ADDENDUM NO: 001

PROJECT NAME: Ransom Canyon Jones-Warner Park
Improvements

PROJECT NO.: 41339.23

This Addendum consists of one page and the attached drawing(s) no(s). Sheet ES100 ELECTRICAL SITE PLAN and E-601 ELECTRICAL SCHEDULES.

A1 ELECTRICAL SITE PLAN
1" = 40'

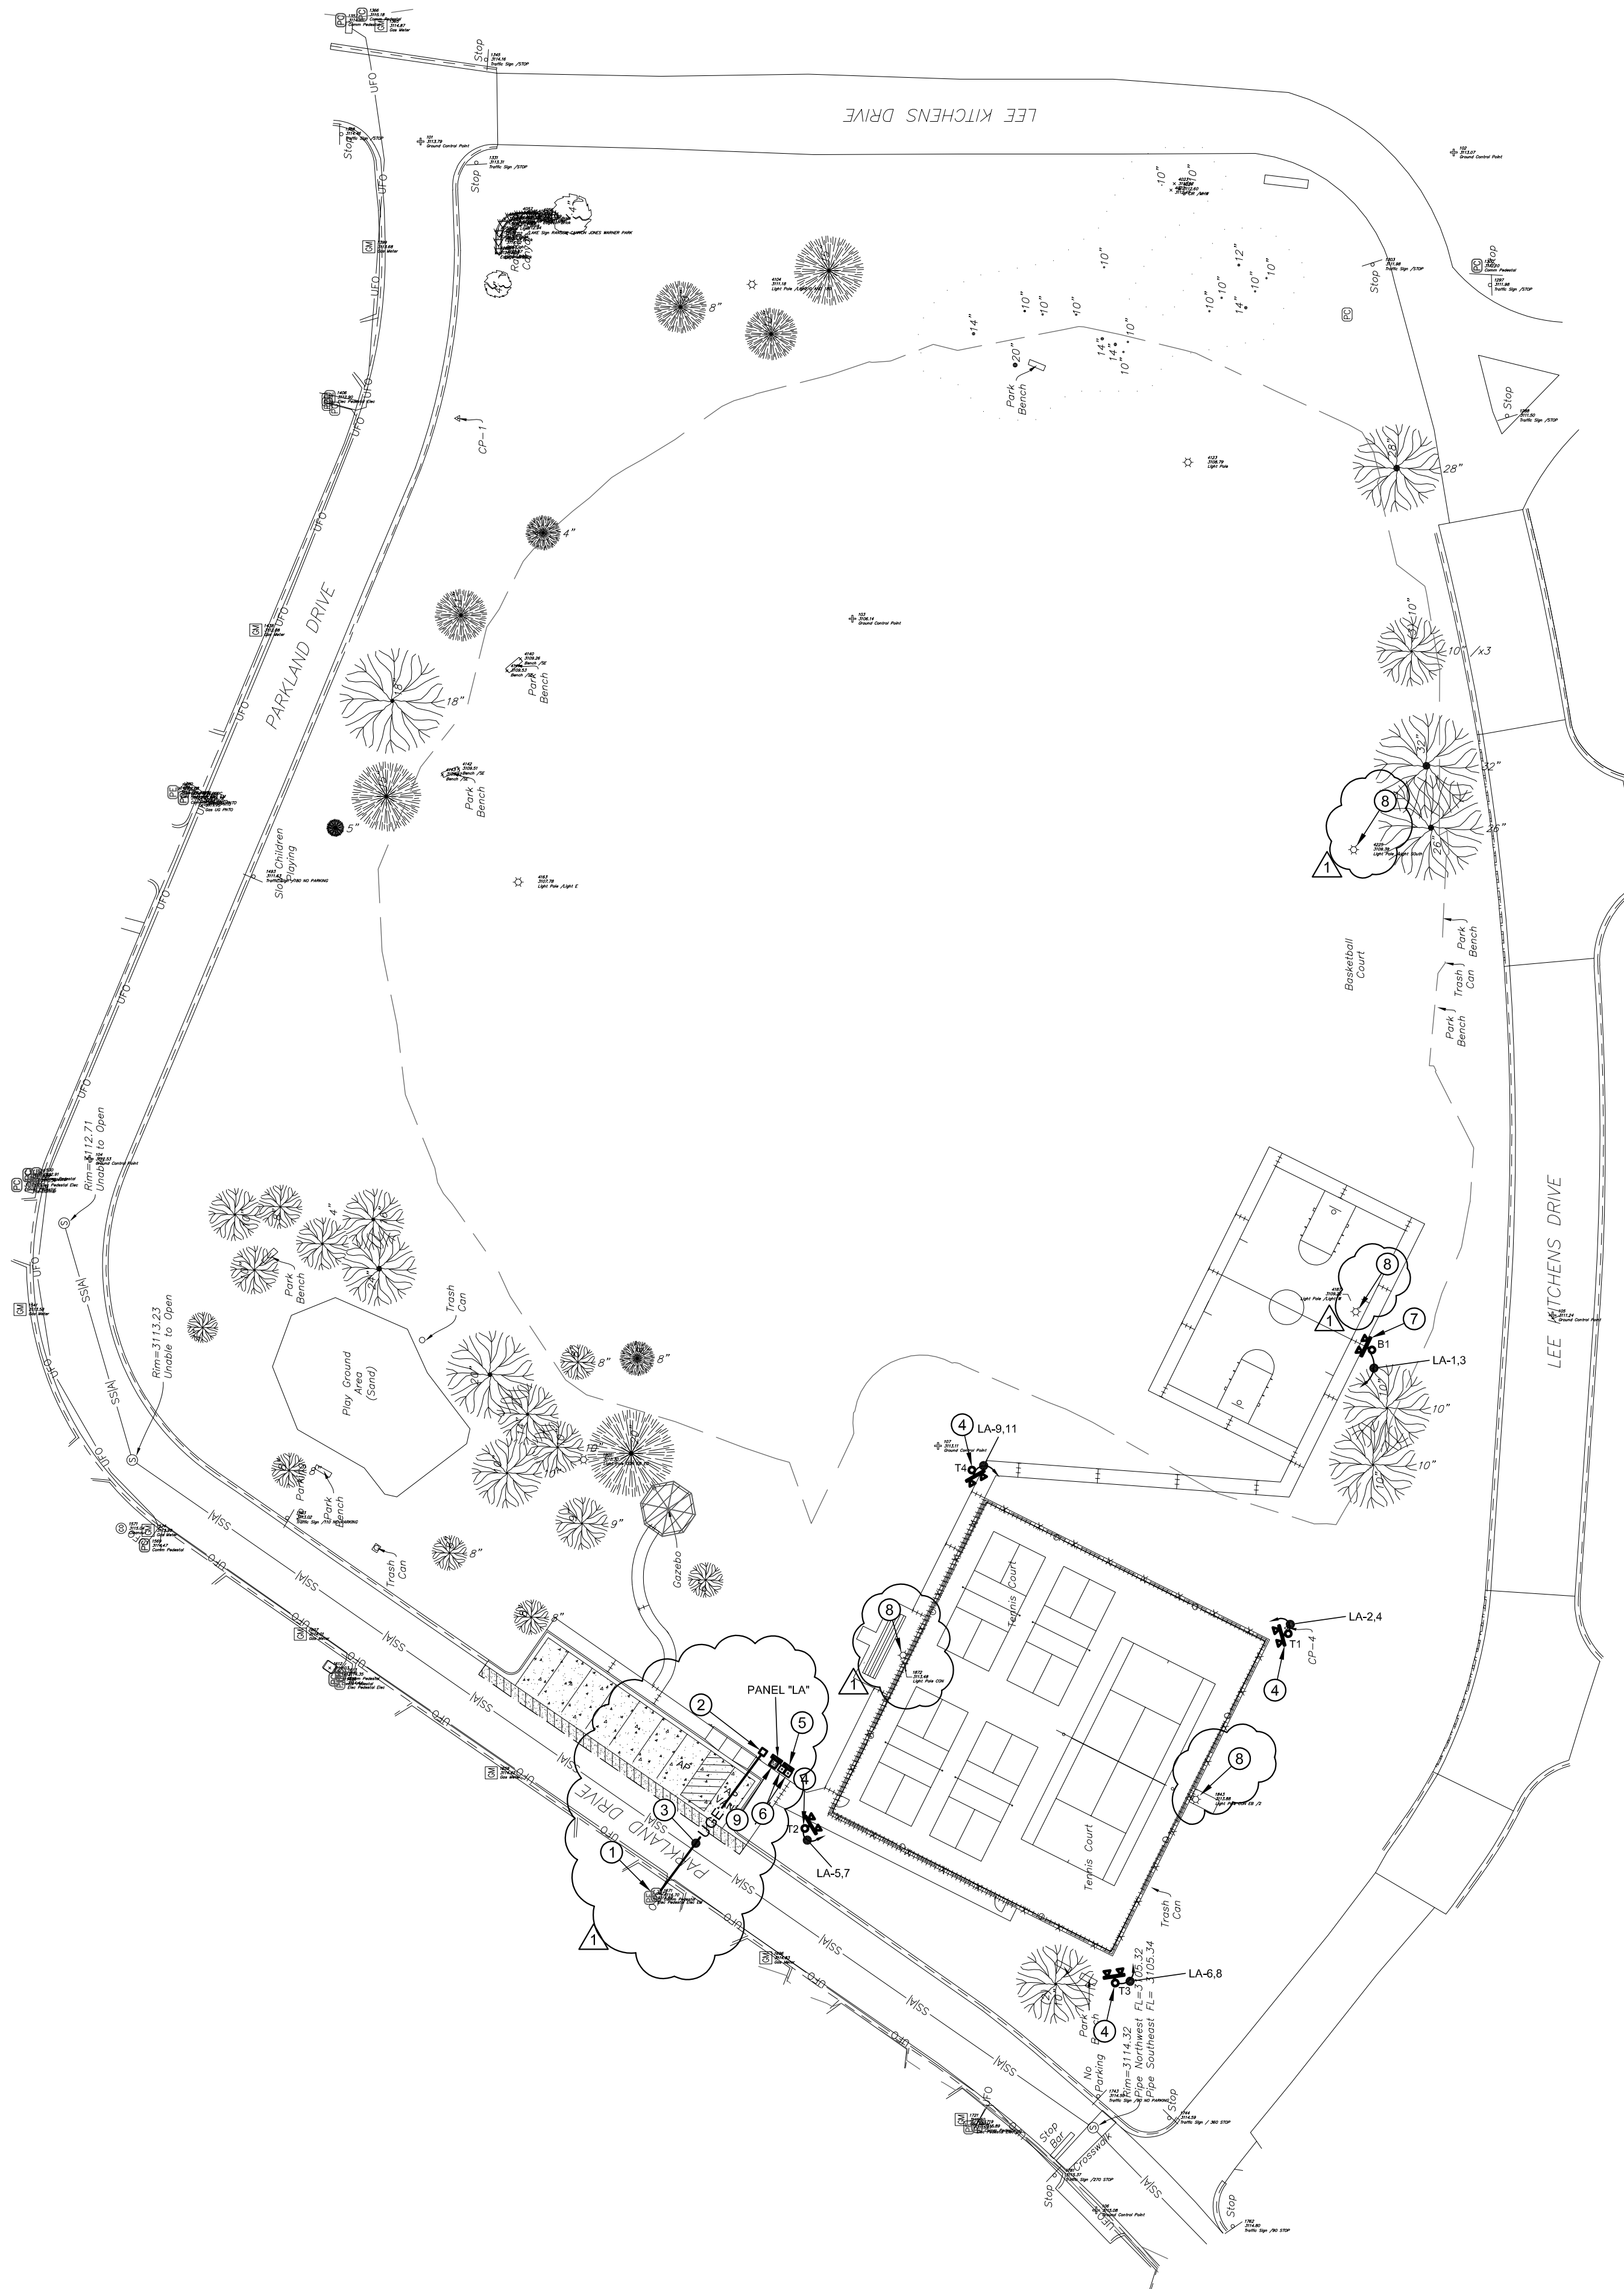
1. SHEET ES100 – ELECTRICAL SITE PLAN
 - a. Relocated electrical service, panel LA, and sports lighting control panel to new location. Refer to sheet for new location.
 - b. Keynotes 1 and 2 have been updated.
 - c. Existing lights that shall be removed have been shown on sheet. Refer to sheet for location and additional information.
2. SHEET E-601 – ELECTRICAL SCHEDULES
 - a. Electrical Riser Diagram has been updated. Refer to sheet for additional information.
 - b. Keynotes 1, 2, and 3 have been updated.
 - c. Rack detail has been updated.
